Specifications for Electrical Installations and Supplements

Errata and Revisions

JANUARY 2021

for the Electric System Bulletin 750 Series

Figure M-1 – Typical Primary Switchgear Metering Transformer Compartment Clearances

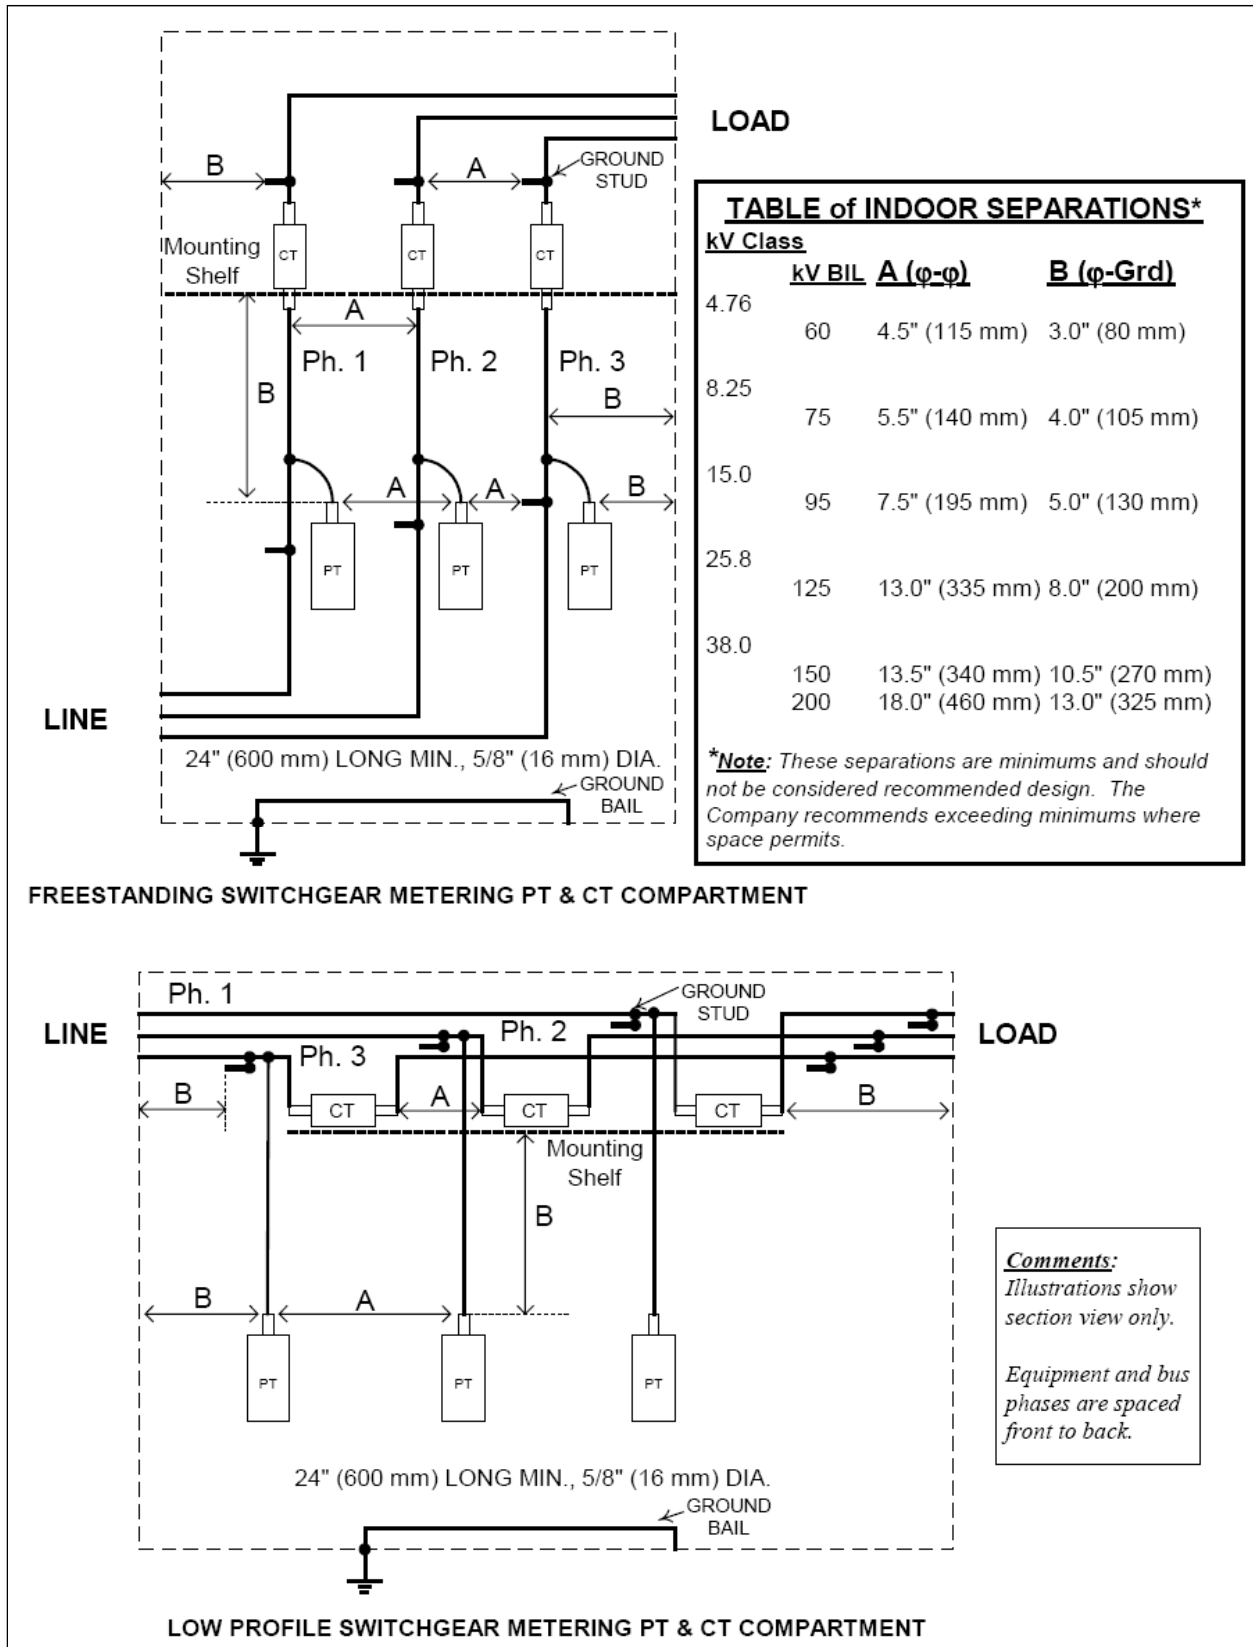
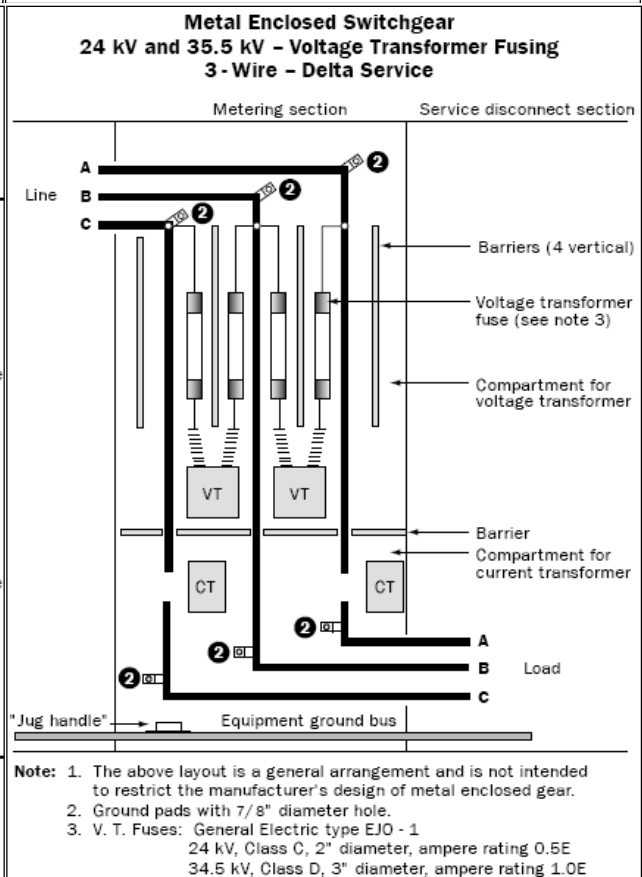
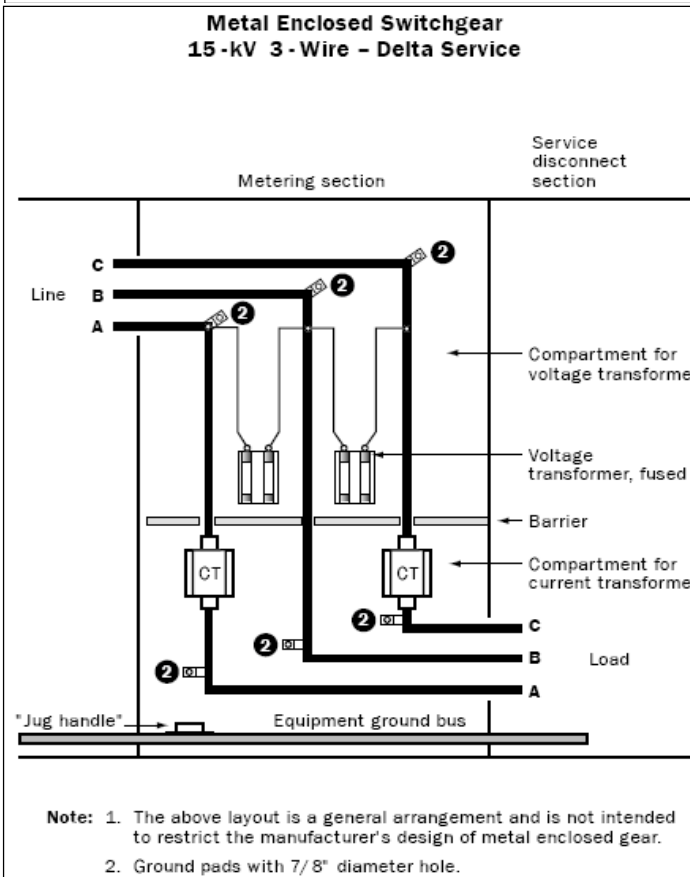
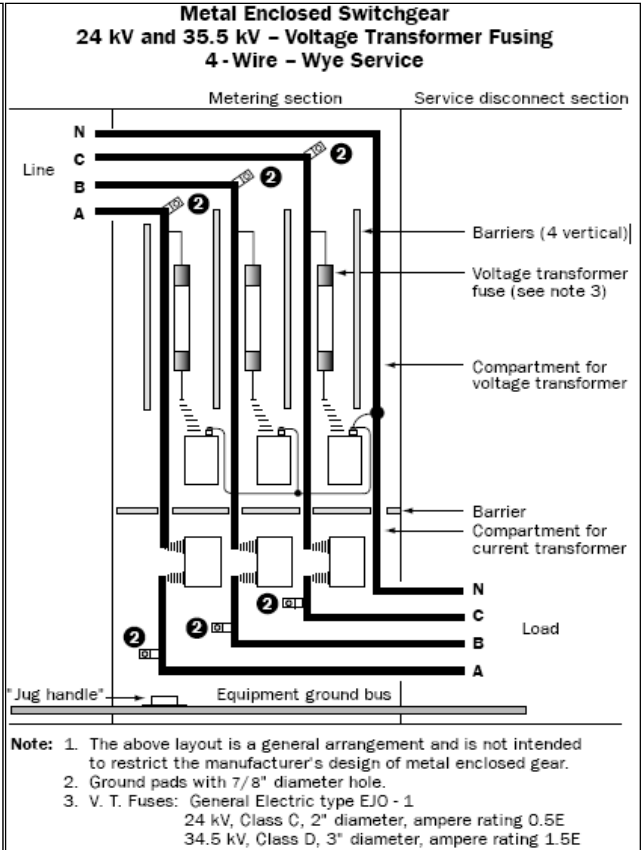
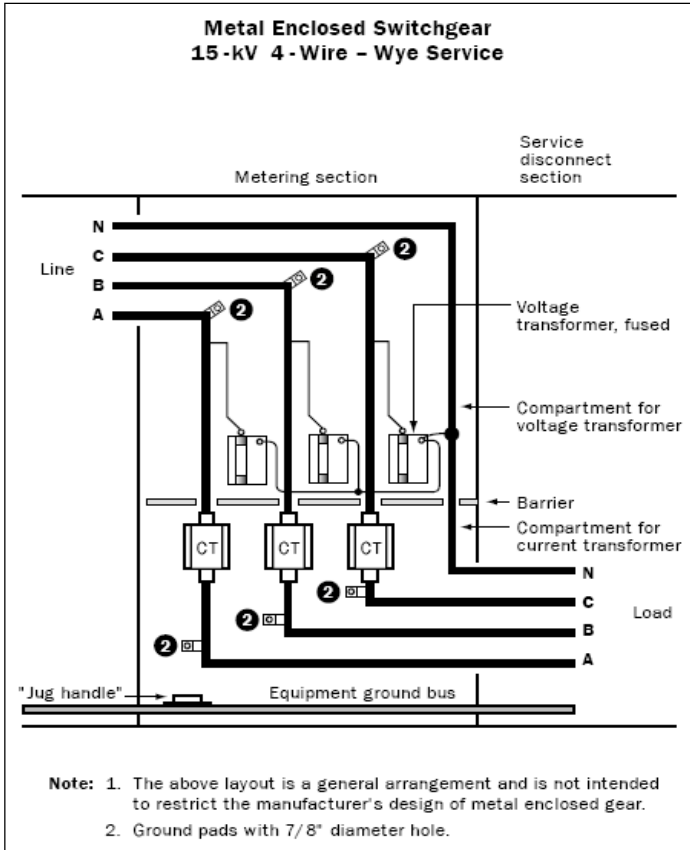
PAGE	SECTION	EFFECTIVE DATE	CHANGE
2	C Paragraph 11	Nov-1999	Delete the Inspection part in its entirety.
3	H	Nov-1999	Delete Paragraphs 18 through 20 and Paragraph 22.
4 and 5	I	Nov-1999	Delete Paragraphs 23 through 26.
5	J Paragraph 28	Nov-1999	In the first sentence, change “outdoor” to “indoor”.
8 - 10	M	Sep-2010	Change this metering section in its entirety and replace it with the new information ** below.
Fig. 1	Note #3	Apr-2002	In Note 3, change “see Paragraph 18” to “see ESB 750 Section 4”.
Fig. 1	Note #4 (new)	Sep-2010	Add new note: “Note #4: The clearances shown from the front of the service equipment to a building wall and from the rear of the service equipment to a building wall shall be both 10 foot (minimum) if the switchgear is designed with the Company required access to the incoming termination compartment on one side while the metering PT/CT compartment is on the other side; see Figure 1A. Otherwise, if the Company’s access to both compartments is on the same side, then the other side’s clearance can be reduced to the clearances presently shown.” Add new Figure 1A ** below.
